IOWA STATE
UNIVERSITY

Docket: 50-116

Subject: Malfunction of the UTR-10 Shim-safety Rod

FIGURE 1a

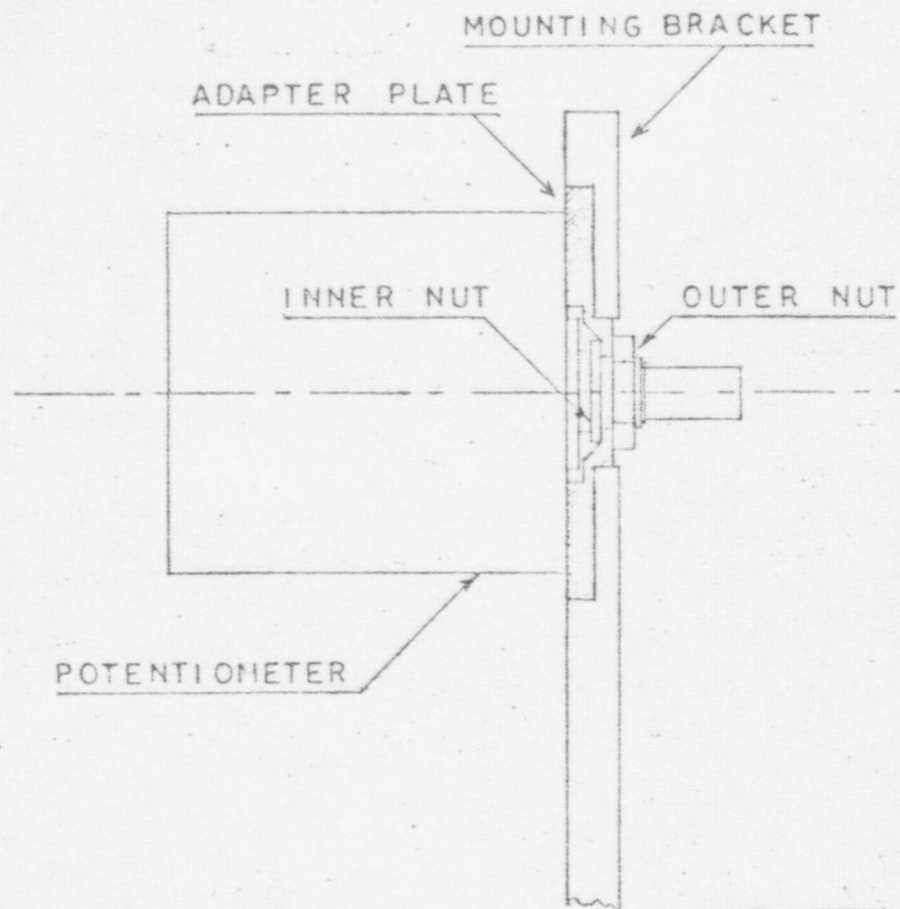
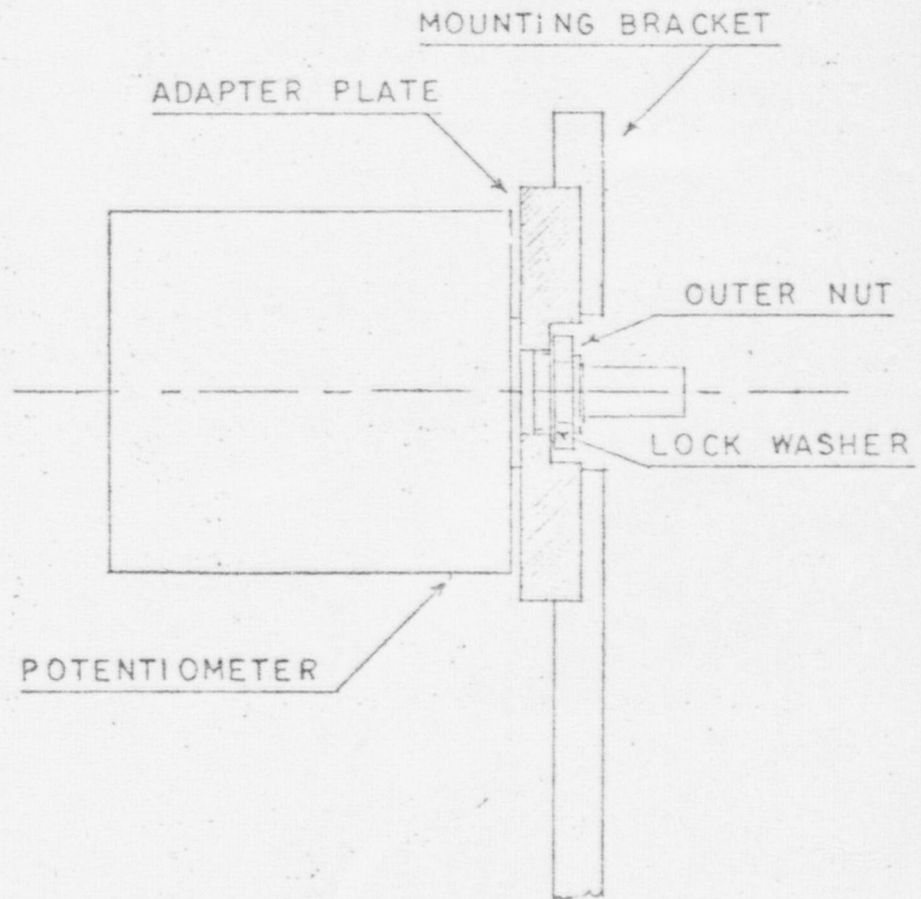
Inspection of the rod drive unit showed that the position potentiometer mounting nut was loose allowing the potentiometer gear to mismatch with the rod drive gear. The mismatch prevented normal spring-force insertion.

Two modifications were initiated. The potentiometer mounting hardware was changed to permit use of a lock washer. See Figures 1a and 1b. A fiducial mark was added to the nut and mounting bracket

to indicate during visual inspection if nut rotation has occurred. Second, the inspection interval has been reduced to six months.
